ADDENDUM #2
JACK REVIGLIO MEMORIAL PARK
BID # 20/21-013 / PWP # WA-2021-168
BIDS DUE NO LATER THAN: 1:45 PM ON MARCH 10, 2021
PUBLIC BID OPENING: 2:00 PM ON MARCH 10, 2021

This addendum is to notify all potential proposers of clarifications made to the Bid documents as stated below.

BID/CONSTRUCTION SET REFERENCE PLAN
JACK REVIGLIO MEMORIAL PARK
 CITY OF SPARKS

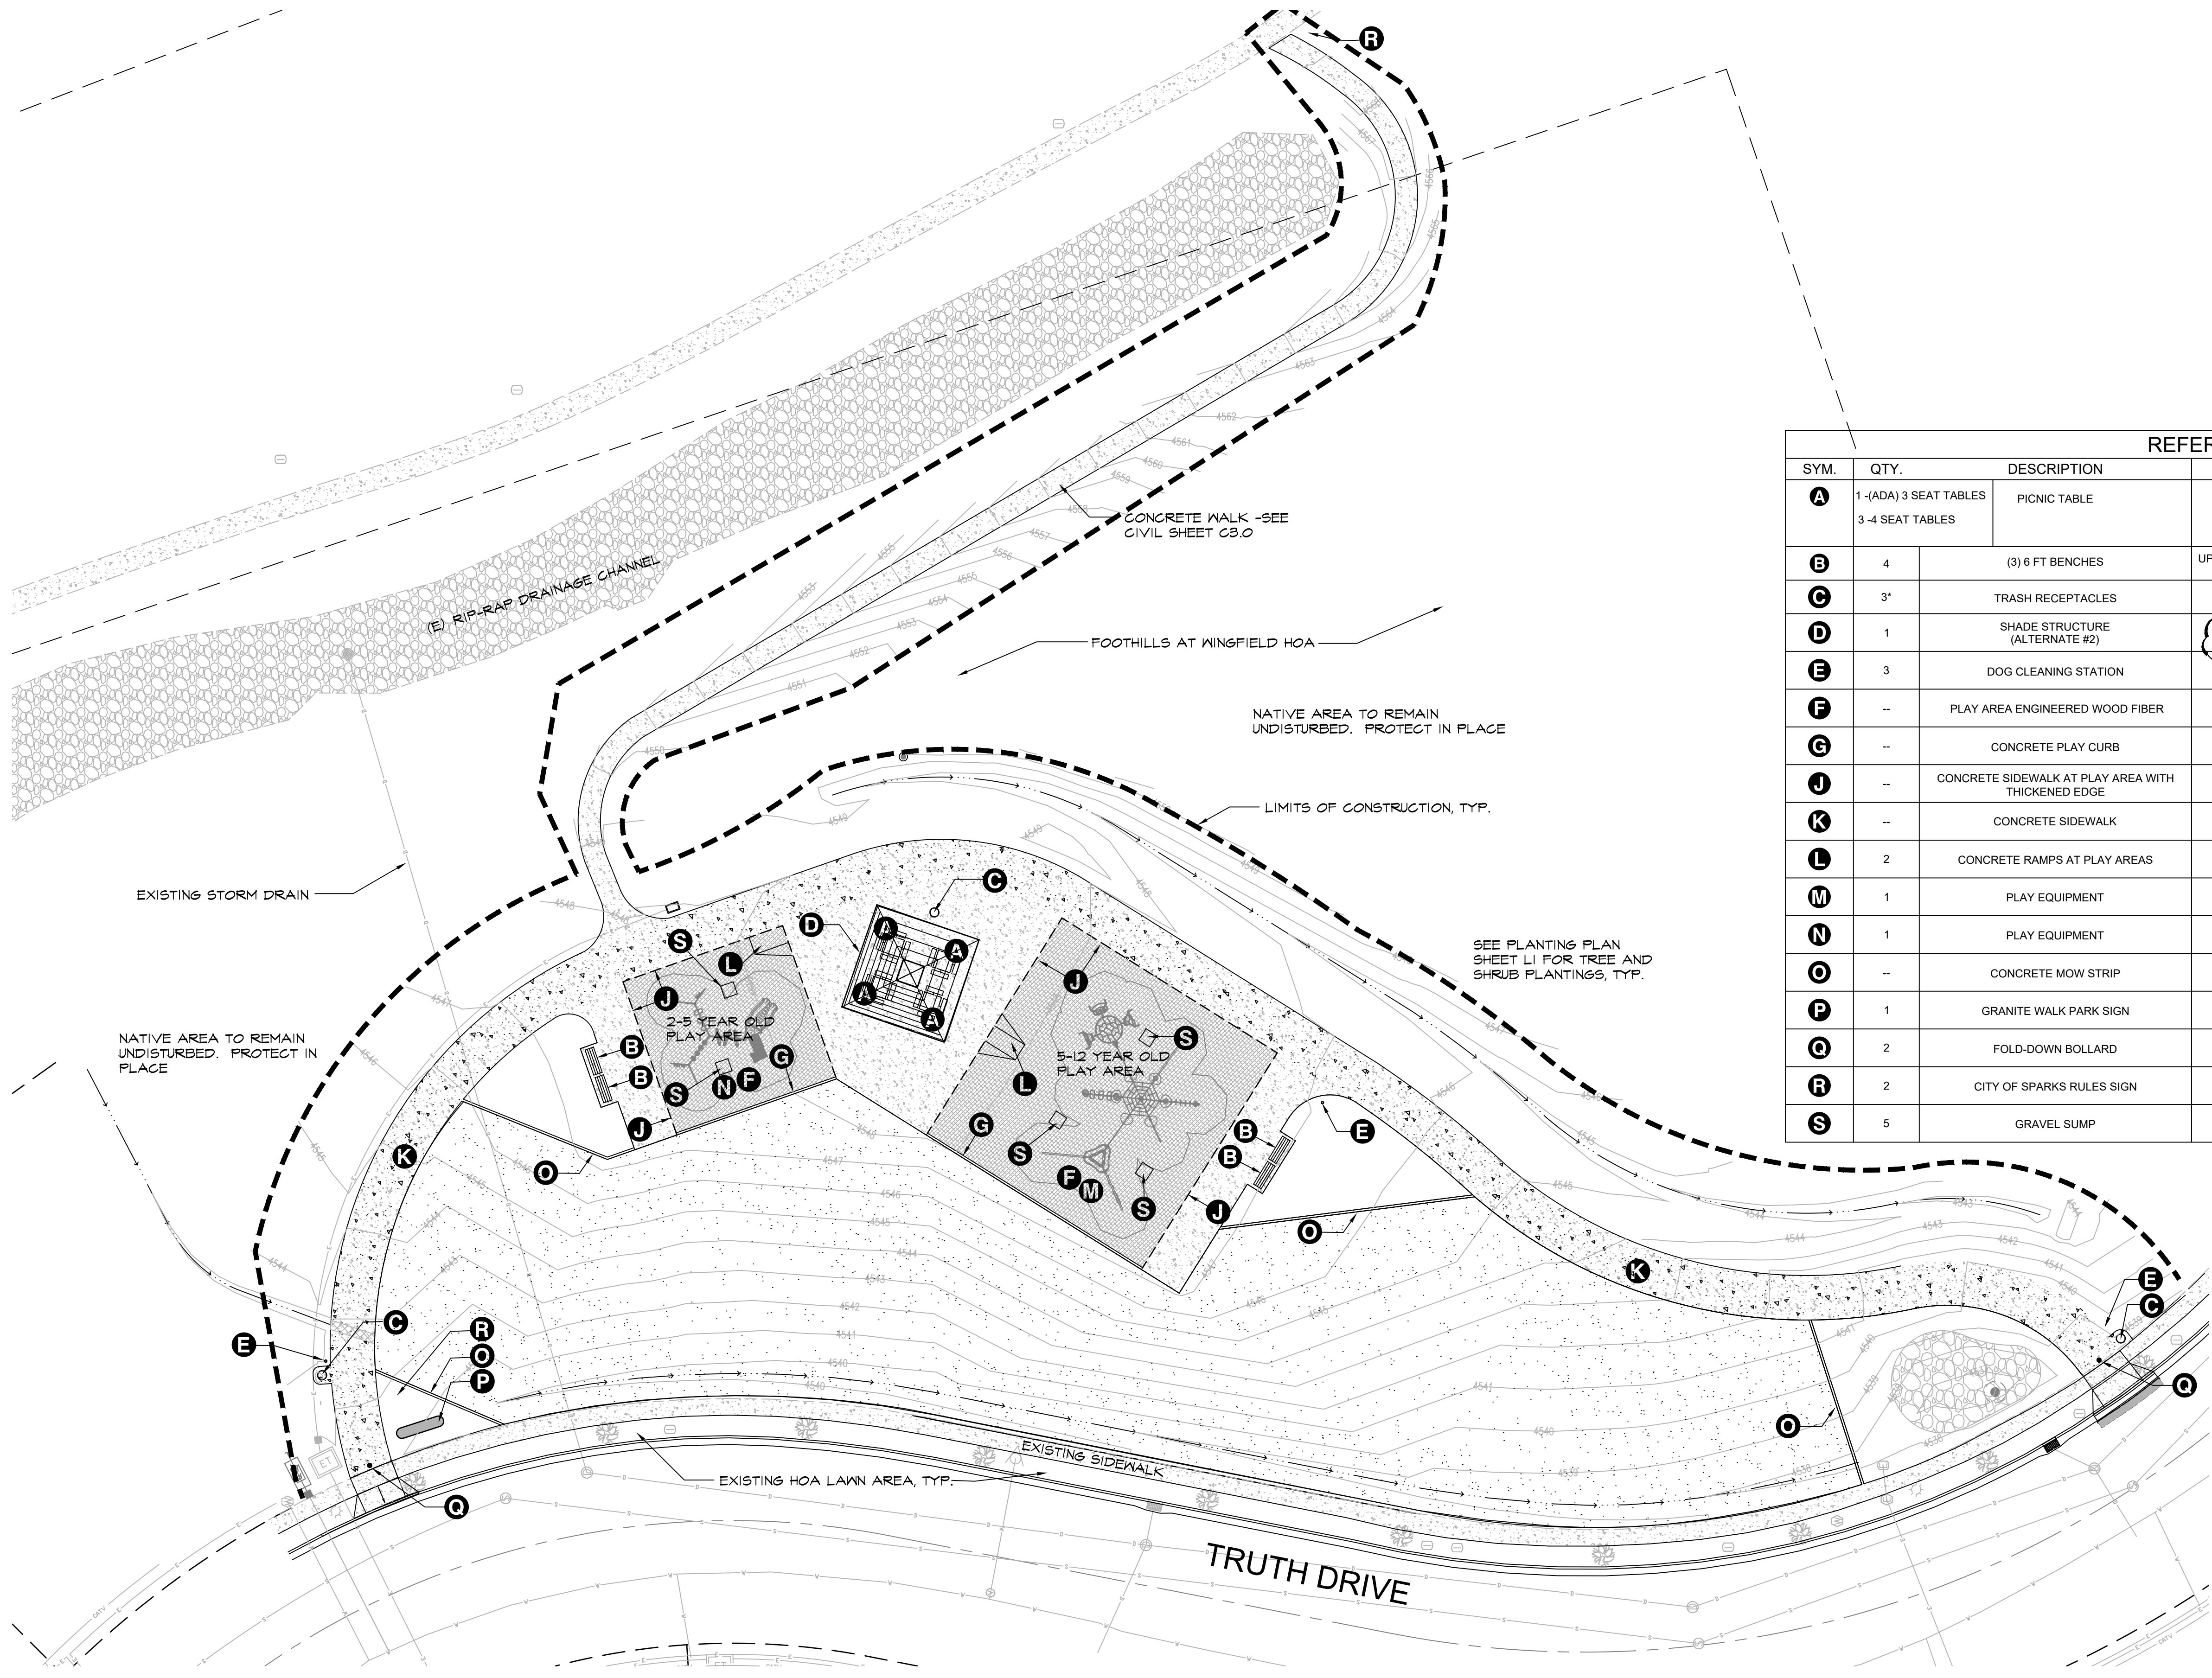
- d. The shade shelter is specified to be an RCP Shelters SLF-SG24-04. No such model appears to exist. Please clarify the model of shade shelter required.

- i. **Answer:** The model number changed during the bidding process. The RCP Shelters, Inc. steel shade structure new model number is TS-SQ24-04. The Reference Chart on the attached revised Sheet L2, has been revised to reference the new model number.

BID/CONSTRUCTION SET ALTERNATE #1
JACK REVIGLIO MEMORIAL PARK
 CITY OF SPARKS
 Washoe County
 Nevada

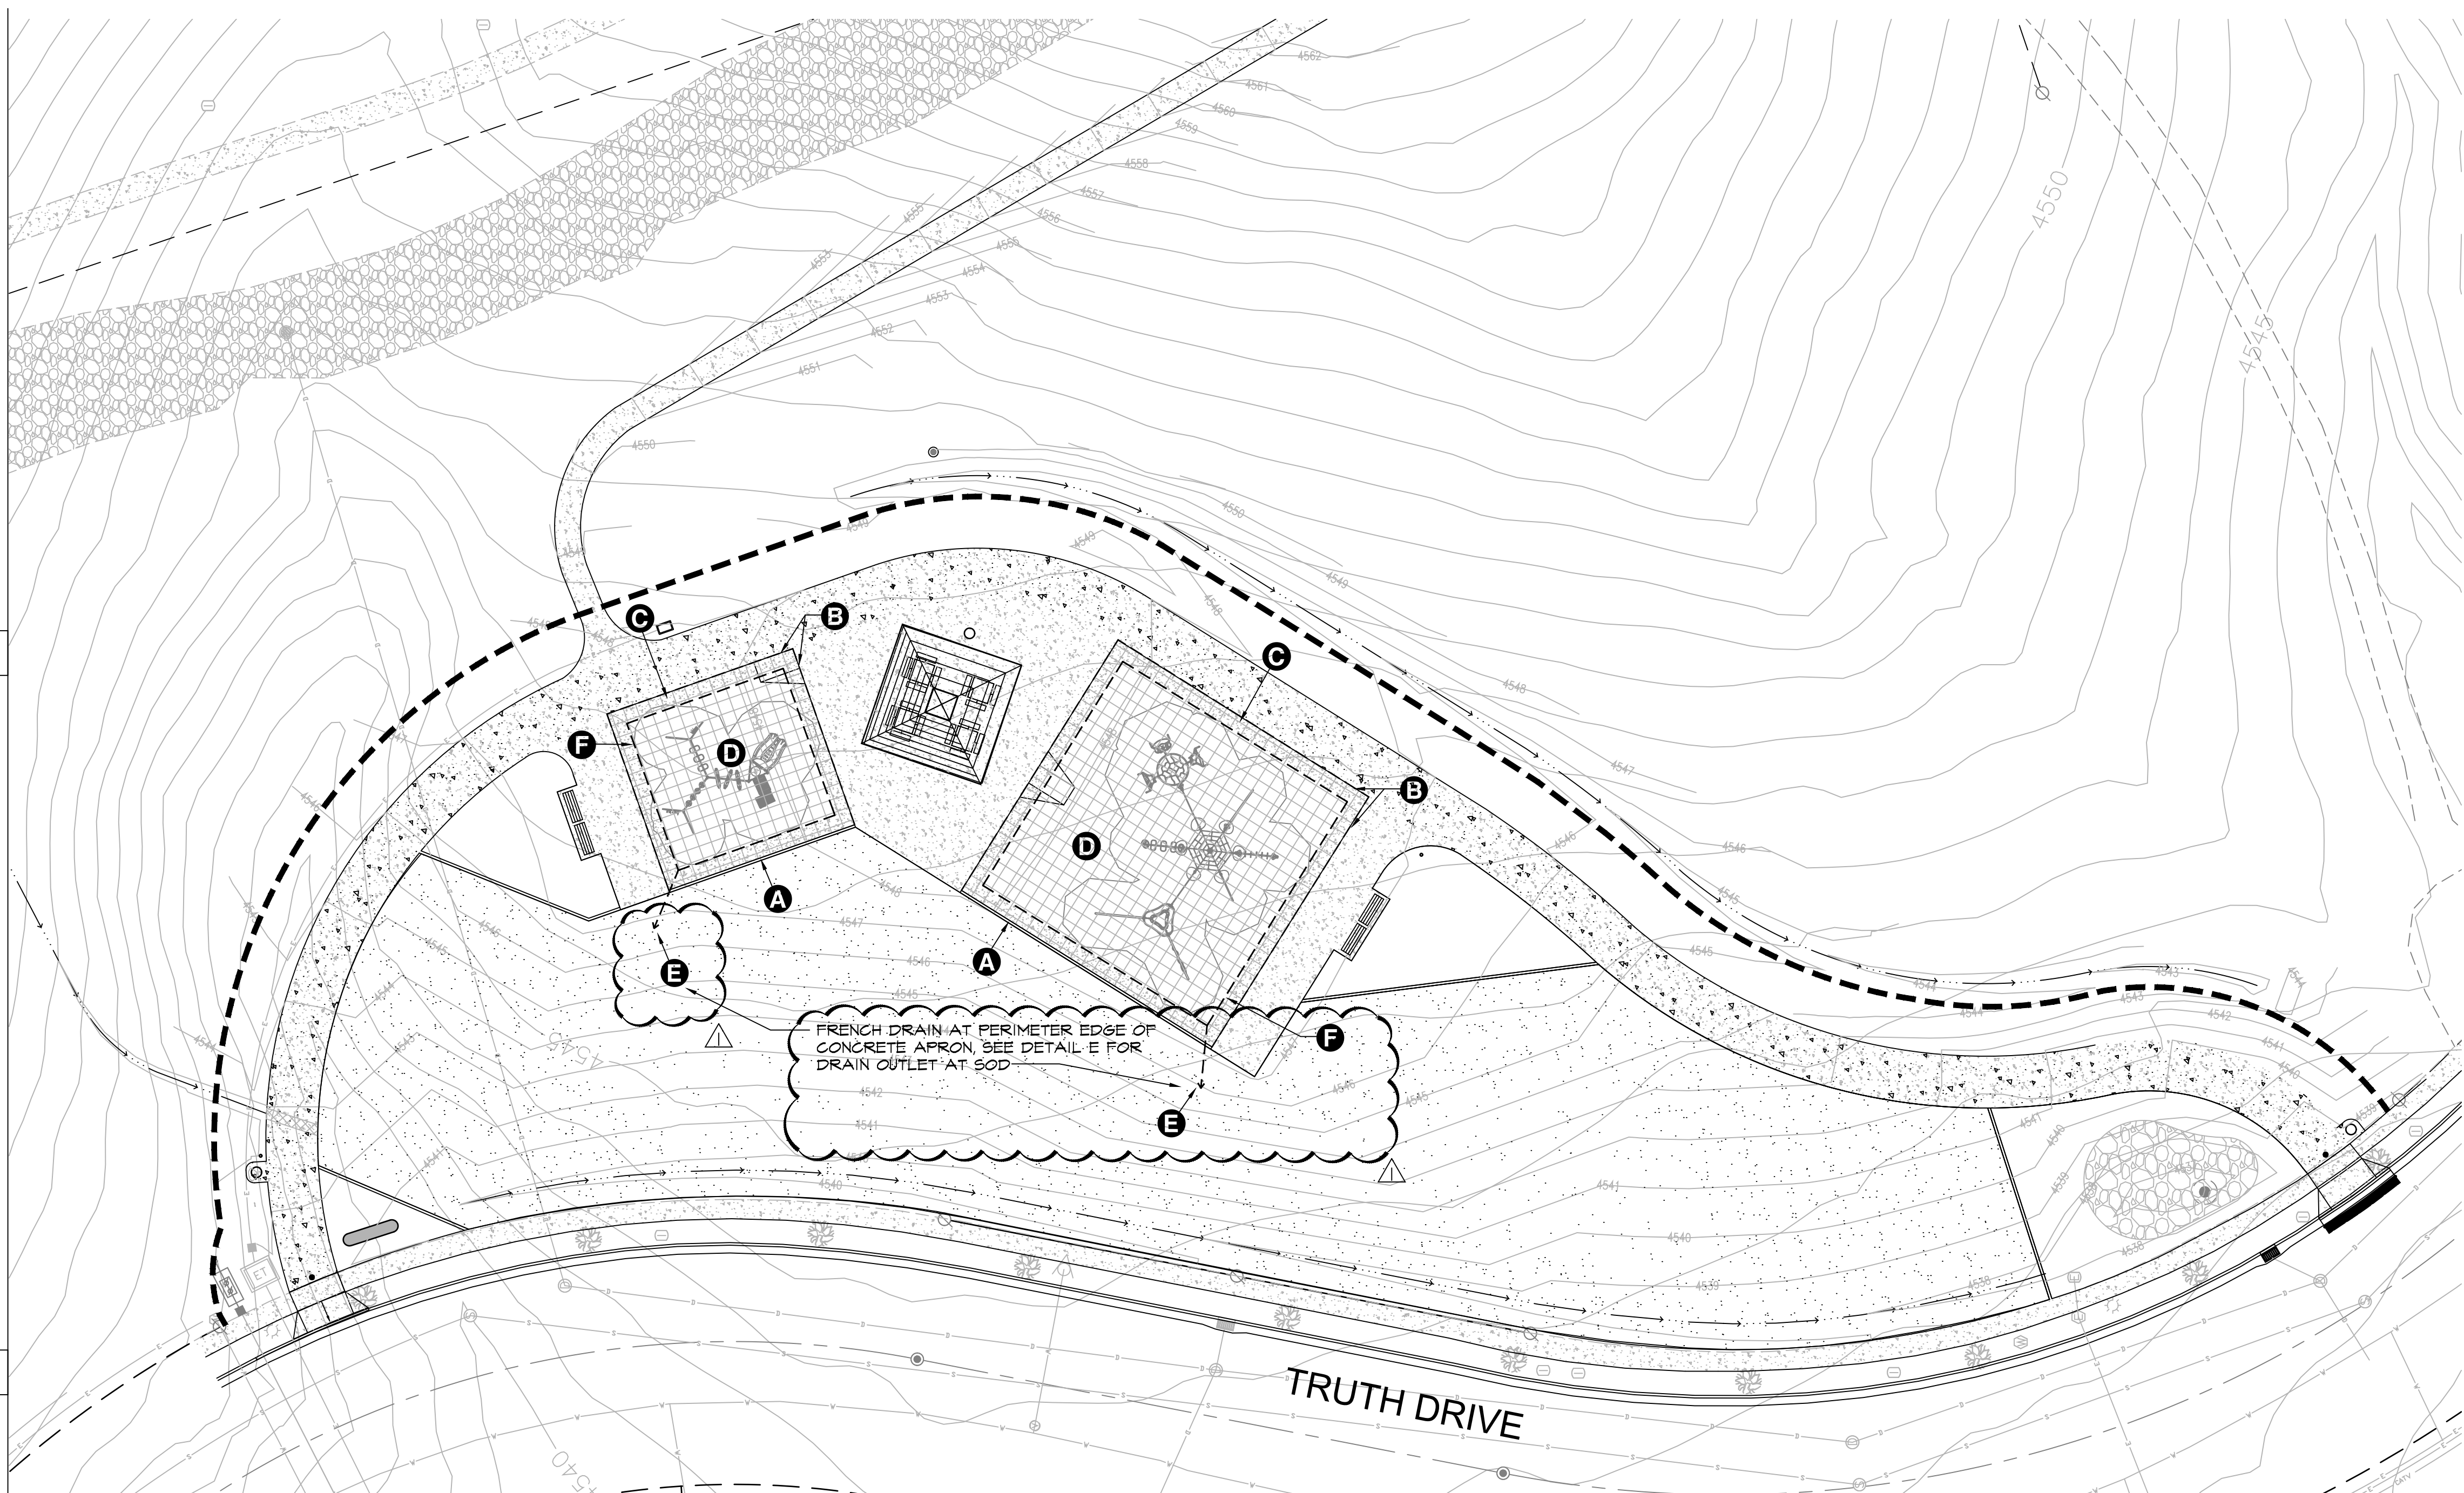
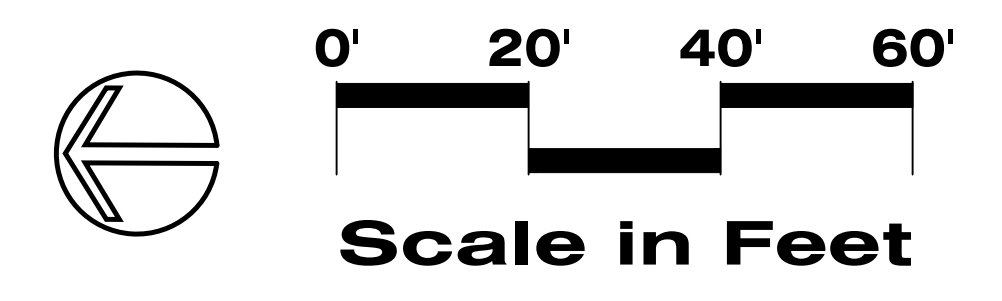
- c. Is there going to be any type of drainage underneath the alt tile installation?
 - i. **Answer:** Contractor shall provide a French drain at the perimeter edge of the concrete apron per attached revised Sheet L7. Refer to the plan and the added details E and F for the design of the French drain system. See revised Bid Item Schedule and Bid Item Clarifications A1.0.

E DRAIN OUTLET DETAIL

F FRENCH DRAIN
